No. VT99004

BULLETIN

TO: ALL AUTHORIZED SERVICE FACILITIES & FSC
FROM: ADALBERTO FERNANDEZ-CAMERA/VIDEO SERVICE
SUBJECT: ES300VA/ES7000VA CAMCORDERS

TYPE 1

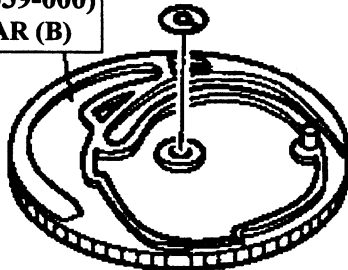
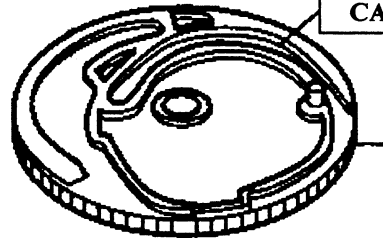
THE "UH" MECHANICAL CHASSIS IS USED IN THE ABOVE MODELS. SEE BELOW FOR CHANGES MADE TO THIS CHASSIS AND NEW PART NUMBERS. THE NEW CAM GEARS (A) AND (B) HAVE BIGGER CENTER HOLES. THE NEW OPERATION PLATE HAS A PIN. THE MODE SWITCH IS INTERCHANGEABLE, USE THE SAME PART NUMBER.

P# (DY4-5523-000)
CAM GEAR (B)

P# (DY4-5603-000)
CAM GEAR (A)

P# (DY4-5604-000)
OPERATION PLATE

P# (DY4-5361-000)
MODE SWITCH
